Addendum to 04V598000 Revised 05-16-05

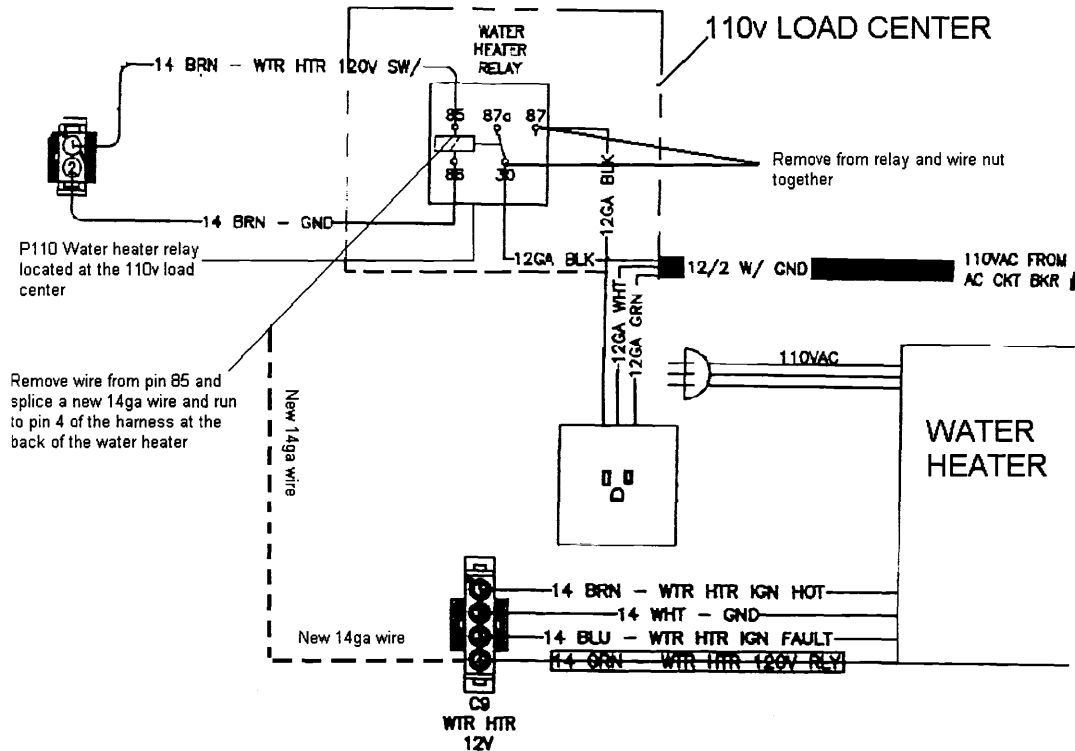
When installing the new Atwood water heater it is necessary to bypass the relay, located in the 110v load center. Remove the two 12ga black wires (30&87) from the relay and connect them together with a wire nut. Then tape the nut with electrical tape. Remove the brown 14ga (may be green on some units) wire position 85 of the relay in the 110v load center. Splice a new 14ga wire to the 14ga wire removed from position 85 of the relay, and route it down to the 4th position (green wire) of the new water heater plug.
